SERVICE INFORMATION BULLETIN

APPLICABILITY: 2013-2014MY Legacy and Outback with EyeSight
2015-2016MY Impreza with EyeSight
2015-2017MY Crosstrek with EyeSight
NUMBER: 06-67-18
DATE: 10/19/18
SUBJECT: DTC C0075- Additional Diagnostic Procedures

Step 2: Stop lamp switch adjustment:

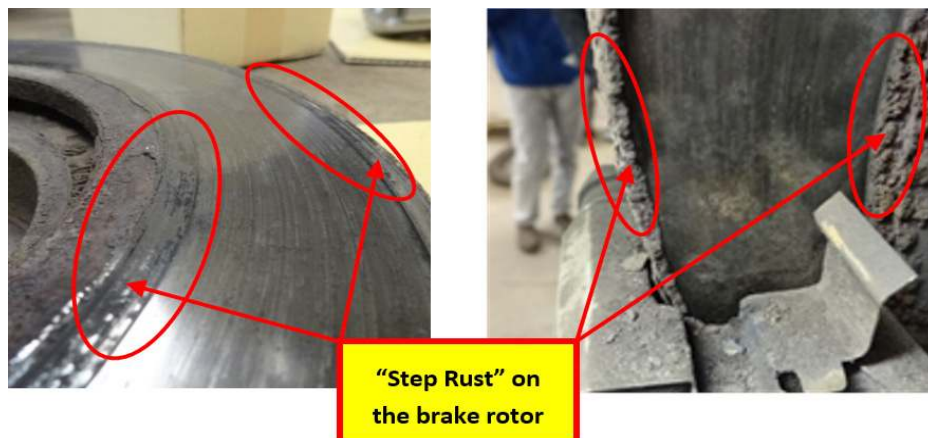
Adjust the stop light switch following the procedures outlined in the applicable TSB:

- For the notched, “Twist-Lock” -type stop lamp switch, see TSB **07-128-18R**.
- For the threaded “Lock Nut” -type stop lamp switch, see TSB **07-131-18R**.
